Addendum No. 2

**Project: Petawawa Centennial Family Health Centre - Addition
154 Civic Centre Road, Petawawa**

- 2.11 Sketch provided below;

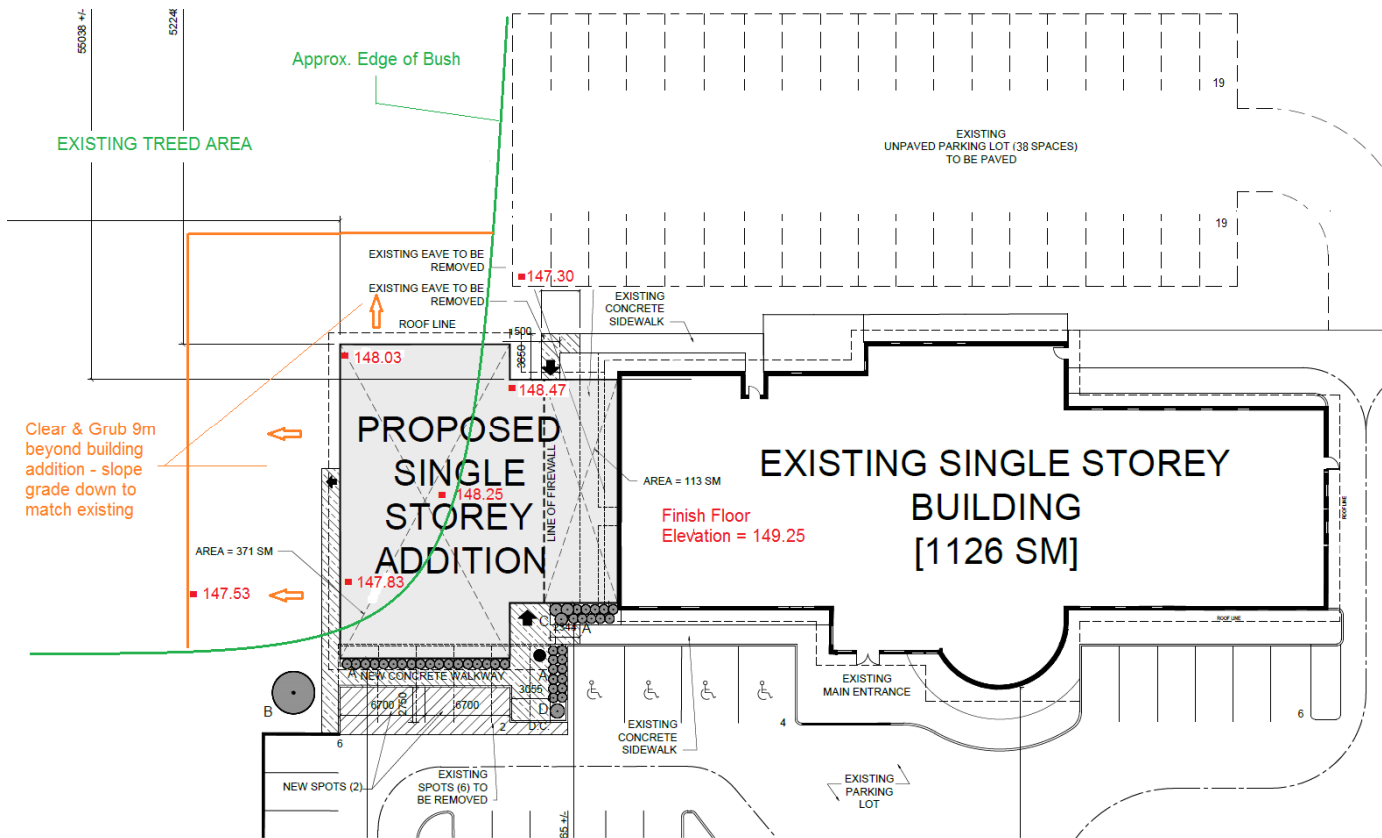
- 2.2 The existing finish floor elevation is 149.25 and the finish floor elevation for the addition will be the same.
- 2.3 Existing grade elevations are noted on the sketch provided below. (shown in red).

- 2.4 The concrete side walk along the west side of the addition is again to be provided as indicated on the sketch below.
- 2.5 The west side of the property is currently treed. A green coloured line has been indicated on the attached sketch to show the approx. edge of the treed area.

- 2.6 Site work contractor to include for clearing and grubbing of existing trees / vegetation to within 9m of the new addition. Include to topsoil and seed disturbed areas upon completion.
